Henderson Development Company
December 11, 2025

Re: Final PUD and Preliminary Plat – Roadway Section Acknowledgment and Commitment

Project: Shaker Meadows

Approved 50-foot Right of Way Roadway Section

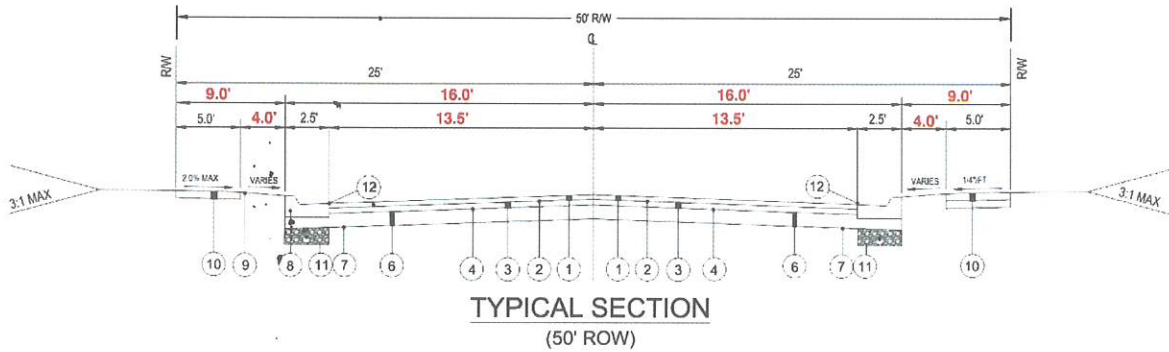
Henderson Development Company acknowledges that the 50-foot right of way roadway section currently shown on the Final PUD and Preliminary Plat is not the correct section. Henderson Development confirms that the roadway section shown below represents the intended and agreed upon 50-foot right of way section for this project and further agrees that this section will be incorporated into the detailed engineering plans and all subsequent construction documents.

- 5-foot-wide sidewalks on both sides of the roadway
- 4-foot-wide grass strip between the sidewalk and curb
- 2.5-foot curb and gutter section

- 13.5 feet of asphalt pavement width on each side of the roadway centerline
- 50-foot total right of way

Henderson Development acknowledges that this roadway design limits on street parking to one side of the roadway, specifically the side opposite the fire hydrants.

The final configuration, dimensions, materials, and design details of the 50 foot roadway section, along with all associated plan sheets, profiles, and construction details, will be updated to reflect this approved section and will be coordinated with and will comply with all comments issued by the City Engineer during detailed engineering review.

The final parking layout, signage, and striping will be coordinated with and shall comply with all comments issued by the City Engineer and the Fire Department during detailed engineering review.
